SERVICE BULLETIN

BULLETIN NUMBER: SB-0054
REVISION: 1-0-0
DATE: JUN 2011

PRODUCT DESCRIPTION: CAUTION:
30W VHF Amplifier – Transistor Change from Max 4W Input Power to Max 6W

DE REFERENCE / ECO: CO 6645

FIGURE 1

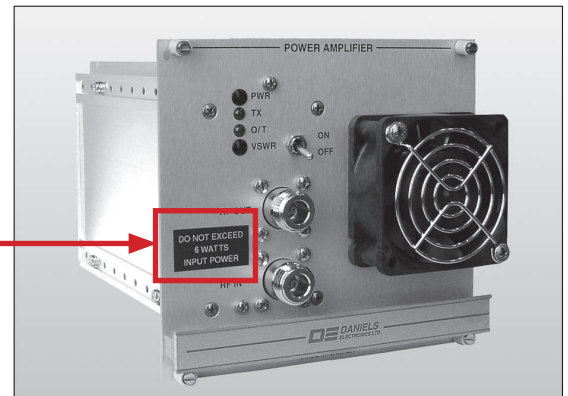
PROBLEM: The RF Transistor MRF646 used in the VHF 30W Power Amplifier is obsolete. A new transistor MRF1946 has been tested and provides acceptable performance in the 136–150 MHz, 150–162 MHz and 162–174 MHz bands.

Pre-CO amplifiers containing the obsolete MRF646 transistor require an RF Input Power of 2–4W. Amplifiers containing the new MRF1946 transistor require an RF Input Power of 2–6W. Concerns have been raised that users who have product with the obsolete transistor and also product with the new transistor may use a 6W input and blow the amplifiers requiring a 4W input.

SOLUTION: Look for the label on the front panel of the 30W VHF Power Amplifier. If the label reads “Do Not Exceed **6 Watts** Input Power” (see Figure 1), the amplifier contains the new transistor. The 6W model has unique alignment instructions and performance specifications. Refer to the manual, *IM71-001 VHF AMP-2 30W Power Amplifier Instruction Manual Version 2-0-0*, which was shipped with this model.
